3.3 Public Water Supply

Figure 3.3-1: Well Location Map
 Raleigh and Heiden Properties
 Town of Fallsburg, Sullivan County, New York
 Site Plan: Glenn L. Smith Consulting Engineer, P.C., 02/10/11
 Scale: As shown

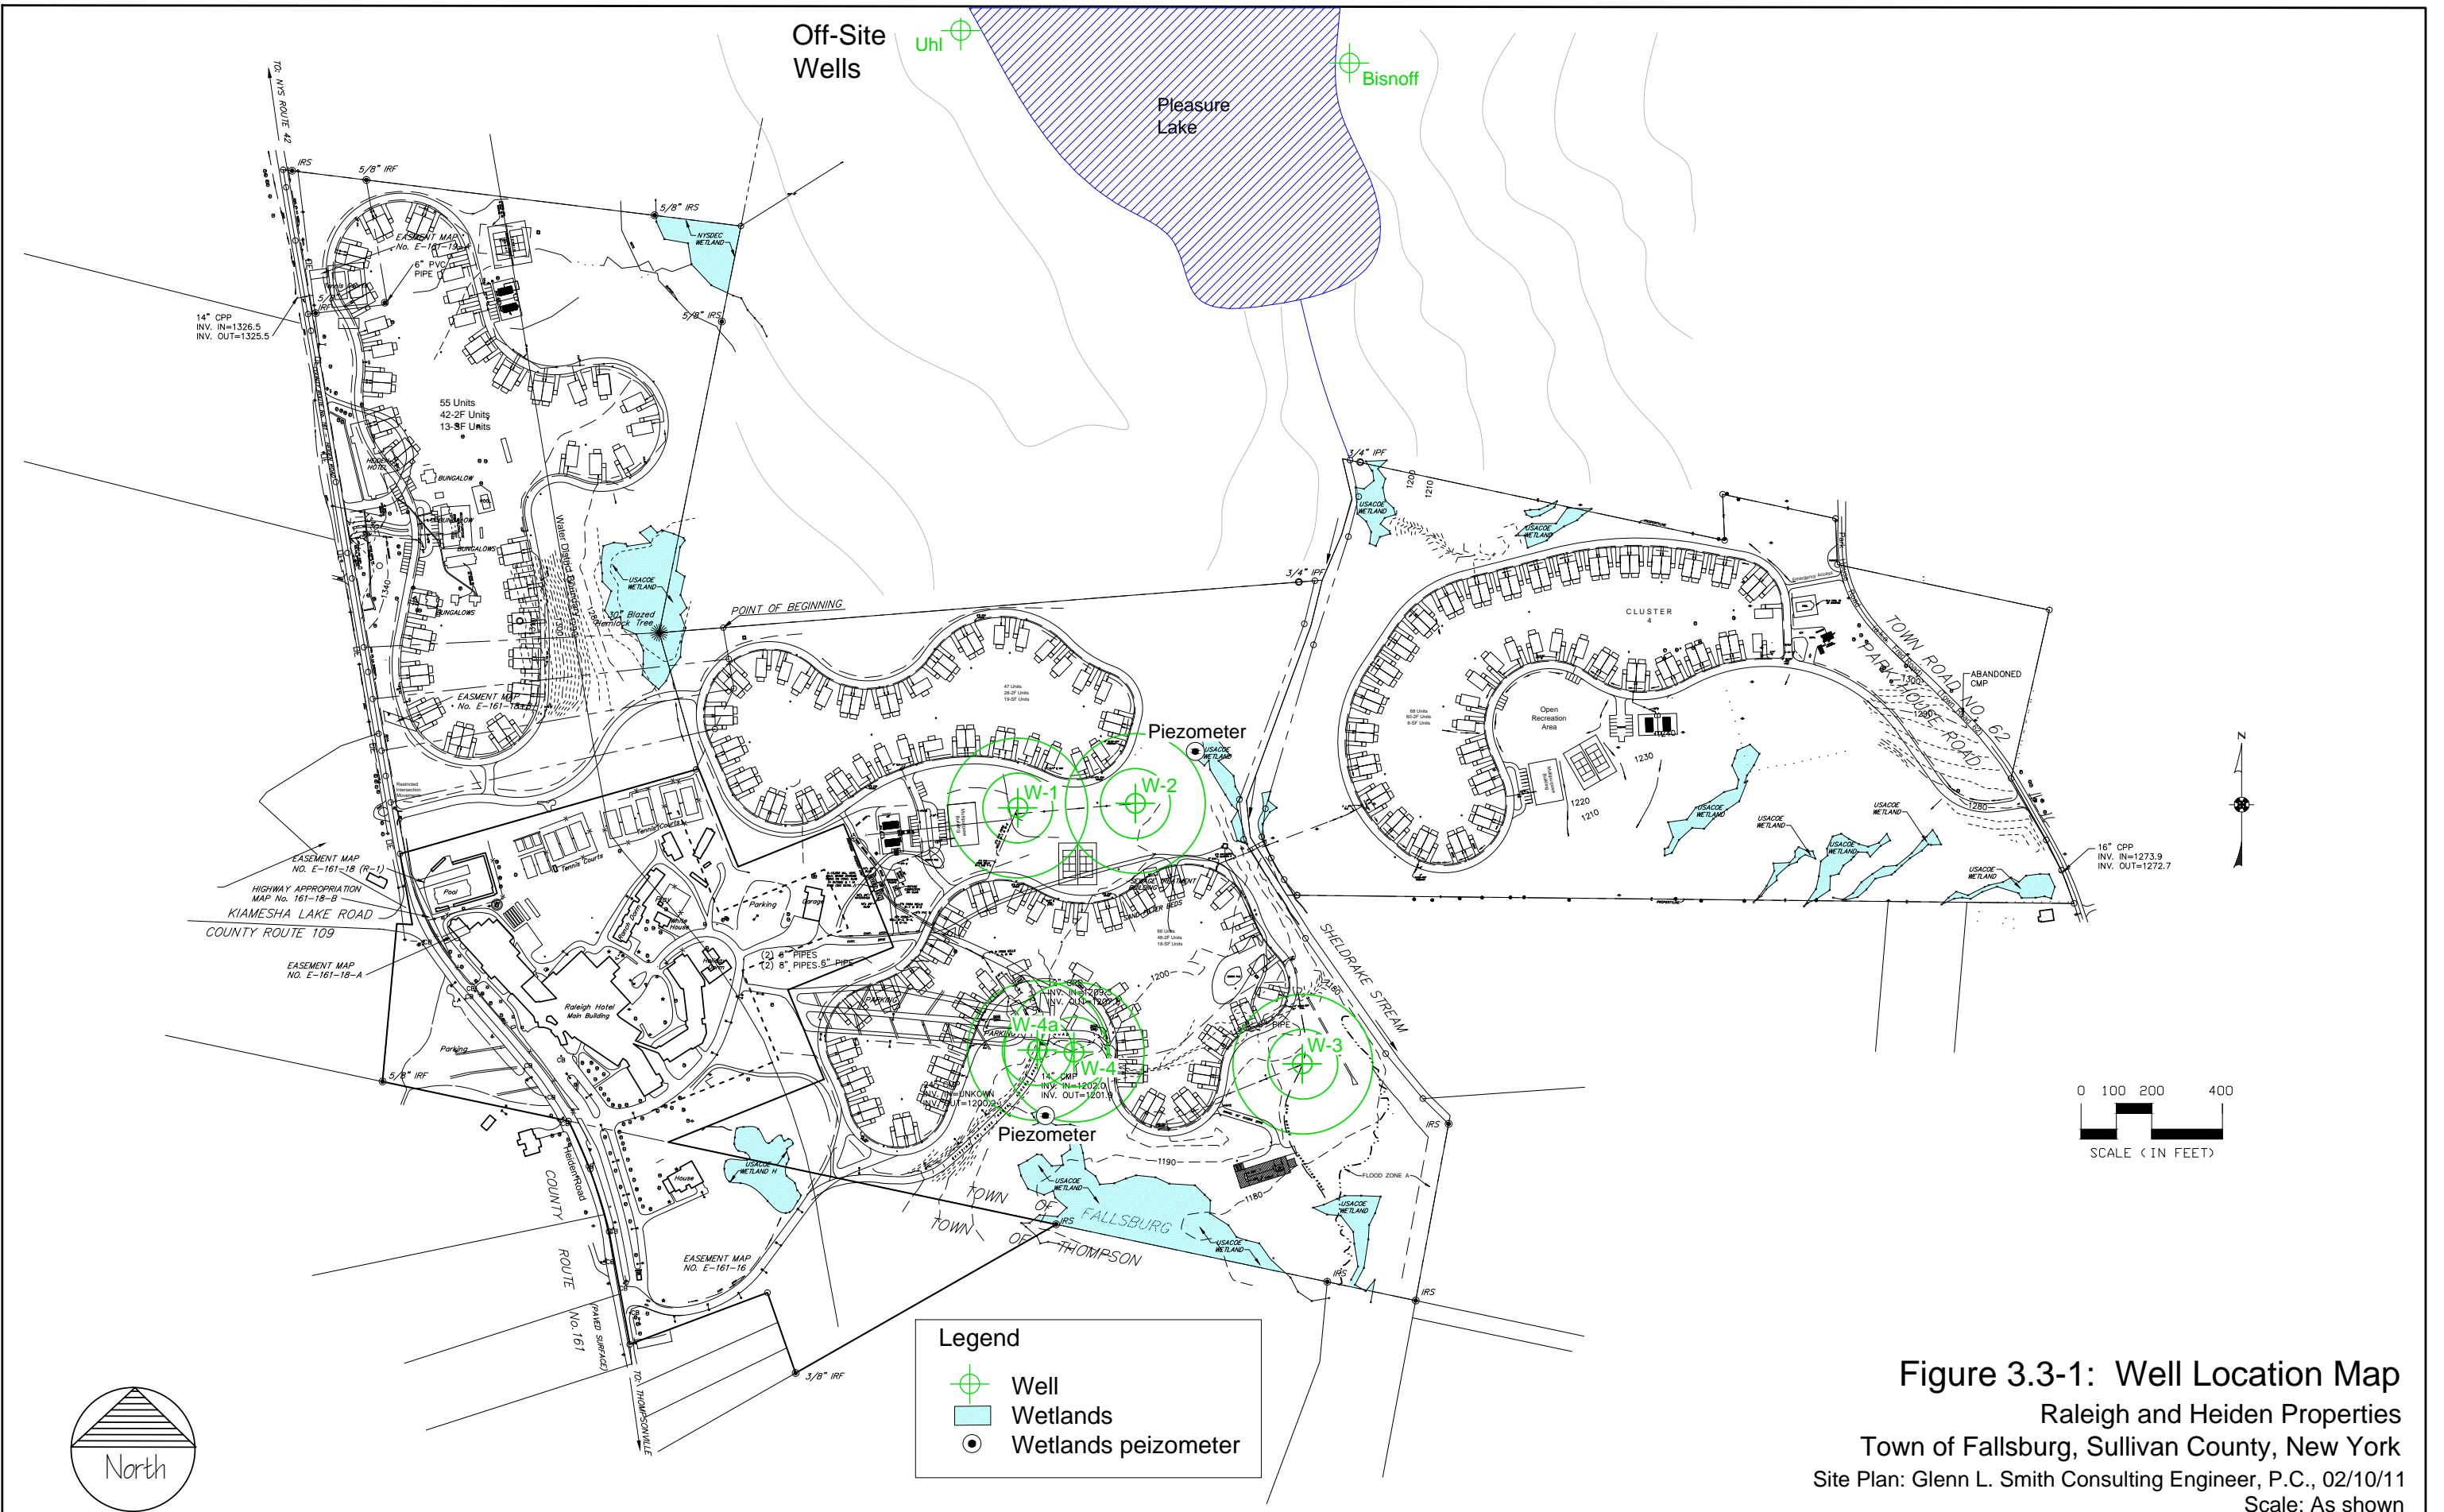
Comment 3.3-13 (Letter to Planning Board, December 16, 2011, Fallsburg Fishing and Boating Club, James Creighton): The maps displayed by the applicant at that meeting completely distorted the locations of each of the wells that were monitored on the West and East shores of Pleasure Lake. For example, the applicant sought to suggest that the effects of the measured well impacts were not significant and showed maps displaying the well for the Uhl family at the southwest corner of Pleasure Lake. As noted in the test results (see, DEIS, Appendix E, Graph 1: *Uhl Well - Lot 26*), the Uhl well is located at lot 26 – directly across the lake from Mr. Bisnoff (who also allowed his well at Lot 52 to be monitored during the applicant's well tests).

Response 3.3-13: The commenter is correct; the two wells that were monitored were not correctly located on the presentation map used at the public hearing. However on a site visit subsequent to the meeting the location of the wells was confirmed. The wells were accurately located on Figure 3.3-1 within Section 3.3 in the DEIS and Figure 5 within the Public Water Supply Report supplied in the DEIS Volume II, Appendix E.
